REMARKS

Application No. 09/482, 135

Amendment Bated April 2, 2004

Reply to Office Action of January 5, 2004

Annotated Sheet Showing Changes

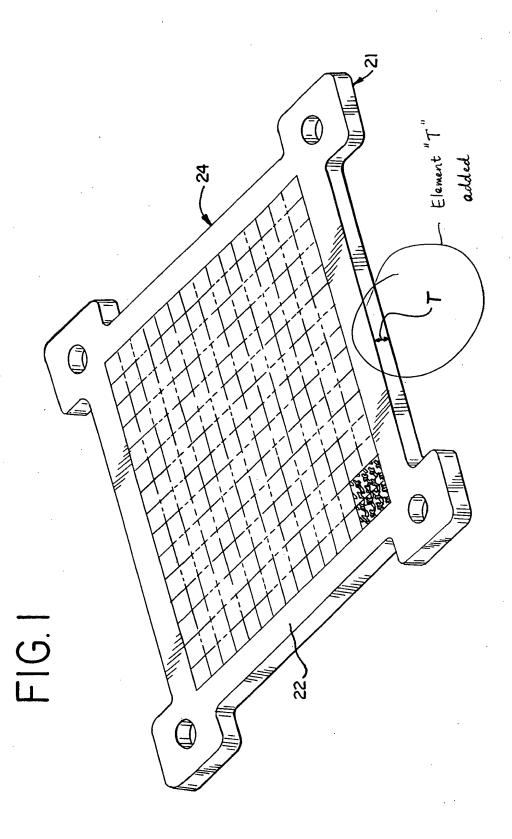
In response to the Examiner's objection to the drawings under 37 C.F.R. § 1.83(a), the applicant has amended Figures 1 and 2 to identify the location of the thickness T of the dielectric housing. Applicant, therefore, respectfully requests that the Examiner withdraw the objection to the drawings.

As shown on the annotated Figures 1 and 2 of Kendall, Jr., the thickness of the housing at the location without the receptacle ("T1") is substantially smaller that the thickness of the housing at the location with the receptacle ("T2"). Thus, applicant disagrees with the Examiner's characterization of Kendall, Jr. As such, for at least this reason, claims 1-4, 6, 11, 13-20, 22, 23, 25 and 26 are not rendered obvious by Kendall, Jr. Accordingly, applicant respectfully requests that the Examiner withdraw the rejection of claims 1-4, 6, 11, 13-20, 22, 23, 25 and 26 under 35 U.S.C. § 103(a) as being unpatentable over Kendall, Jr.
